1964 - 1966 Corvette: Service Bulletin: Gear Shift Control Assembly Buzz

Source: Chevrolet Technical Service Bulletin

Bulletin No: TSB #66-65

Date: June 13, 1966

FIGURE 1

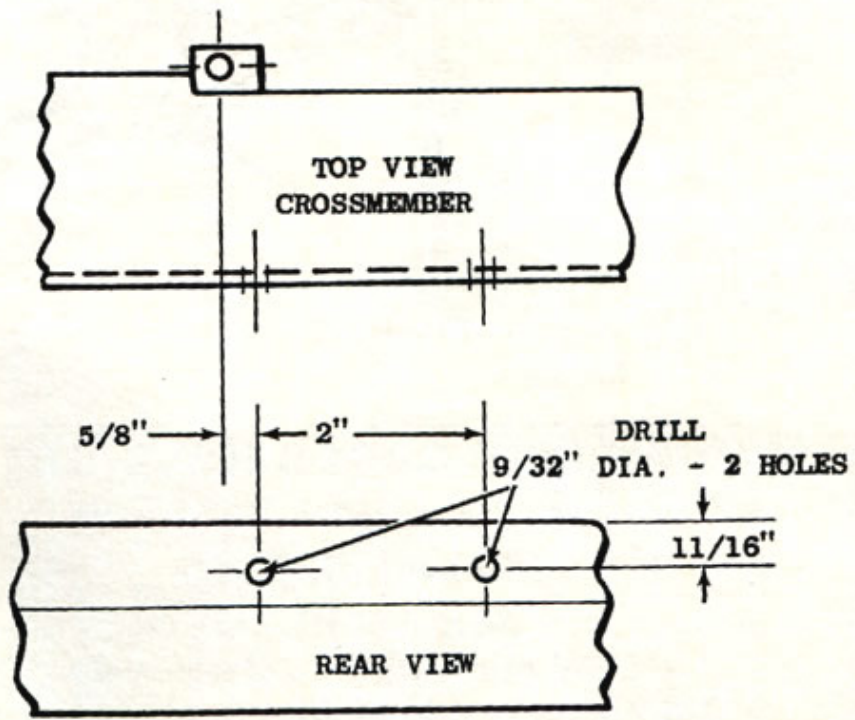
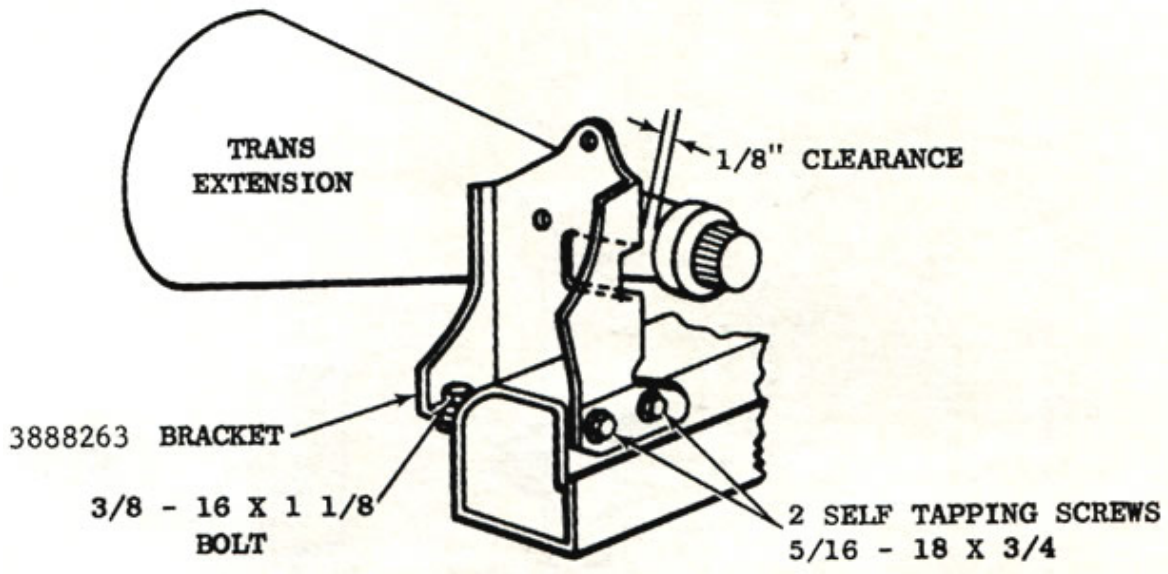
7. Scribe a line 11/16" down from top surface of crossmember on rear side (See fig. 1.)
8. Move new bracket, Part No. 3888263, into position from rear of crossmember.

9. Loosely install bolt through front leg of new bracket through mounting tab on front of crossmember (center in slot). (See fig. 2, item 6.)
10. Using bracket as template, locate position of holes to be drilled at center of bracket slots. (fig. 1)

11. Remove bracket and drill two 9/32" holes in rear of crossmember. (See fig. 1.)
12. Loosely install new bracket using two 5/16" self-tapping screws and washers at rear attachment. (See fig. 2, items 4 and 5.)

15. Reinstall transmission mounting assembly and bracket and exhaust support. Tighten all bolts securely with exception of bolt holding new bracket.
16. Adjust new bracket laterally to provide desired 1/8"* clearance between transmission extension and bracket, then tighten bracket

screws securely. (See fig. 1.)

* Clearance in excess of 1/8" may cause binding in reverse operation.

FIGURE 2

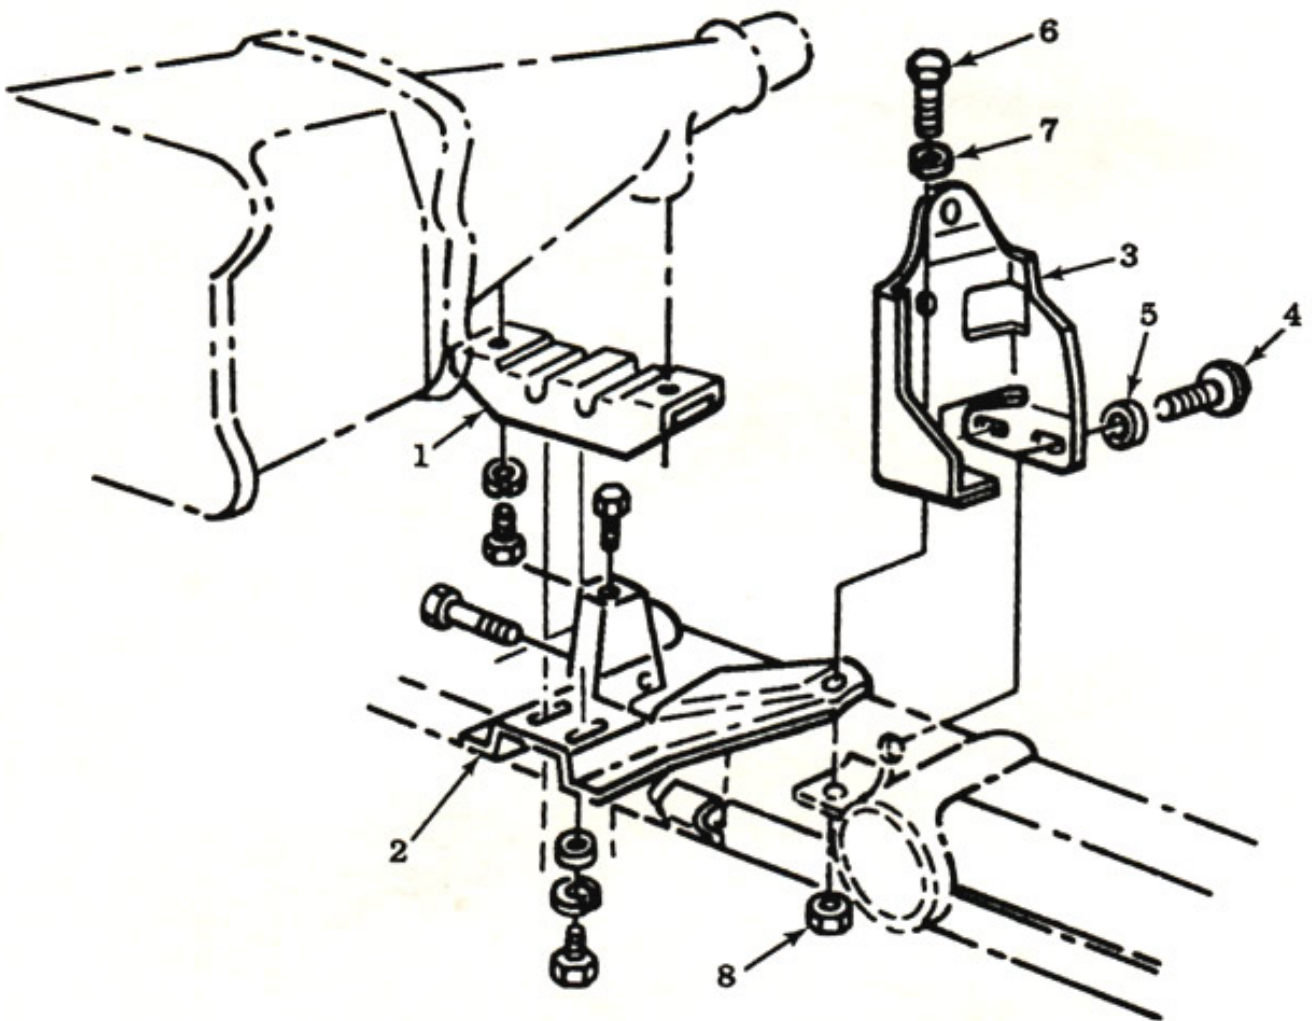
1. Remove shift levers at transmission.
2. Position jack stand under transmission and remove transmission mounting assembly and bracket. (See fig. 2, items 1 and 2.)
